**ADDENDUM NO. 2
TO
DOCUMENTS AND SPECIFICATIONS
FOR
PRV/BOOSTER/CHLORINATION FACILITY
1553 TEN ROD ROAD
NORTH KINGSTOWN, RI**

TOWN OF NORTH KINGSTOWN
PRV/BOOSTER/CHLORINATION
FACILITY

SECTION DETAIL AND ROOF
NOT TO SCALE

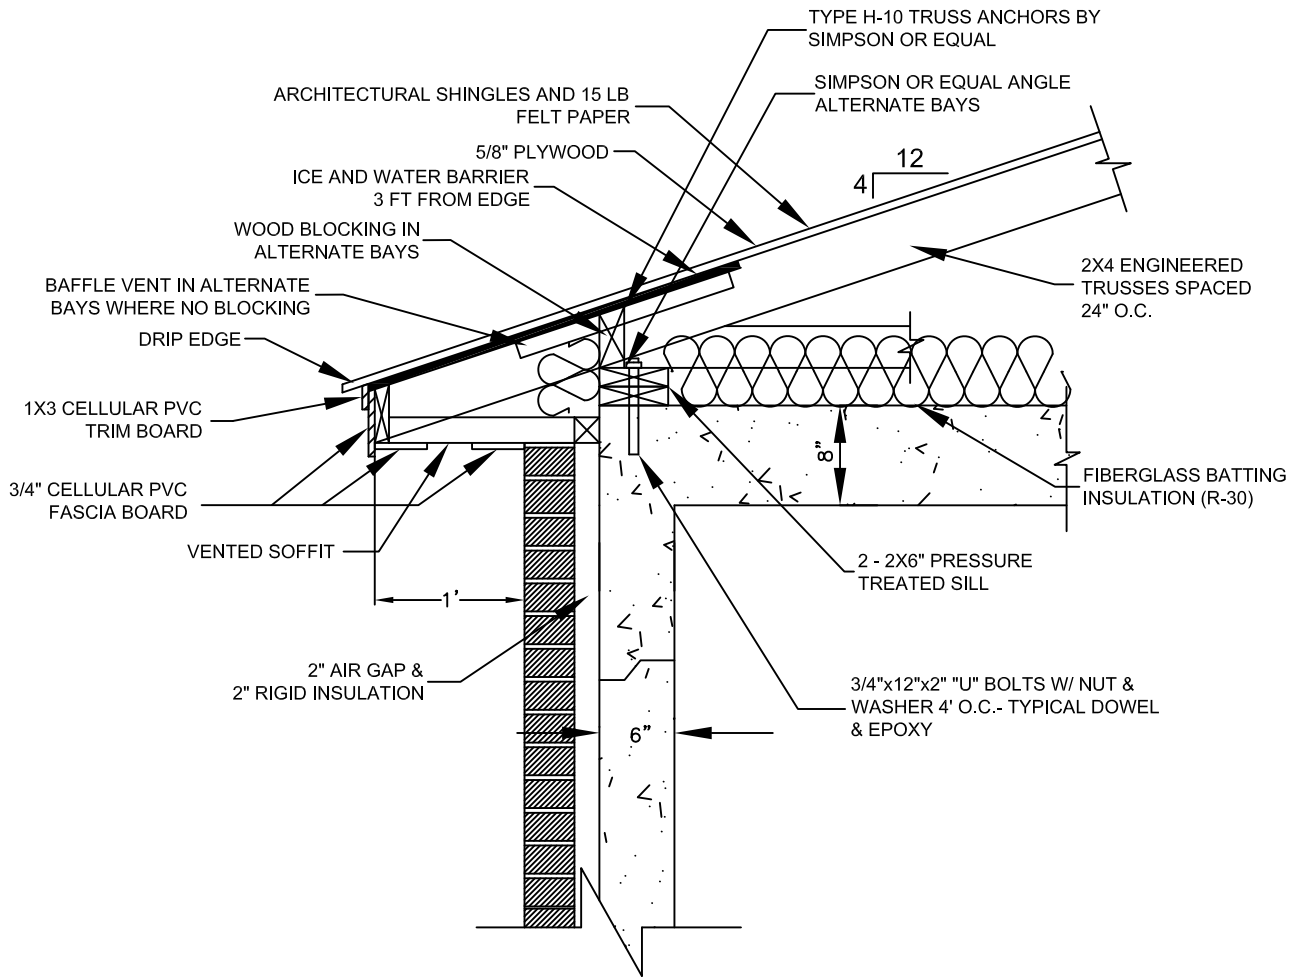
1. CONTRACT DRAWING NO. A-2
 - A. Base of Wall Detail. Delete the works “Air/Moisture/Vapor Barrier (A/M/V) – As Required” and replace with the words “Dampproofing – Required”.
 - B. Section Detail and Roof. Replace this detail with the attached revised Section Detail and Roof detail, Plate SKA-1.
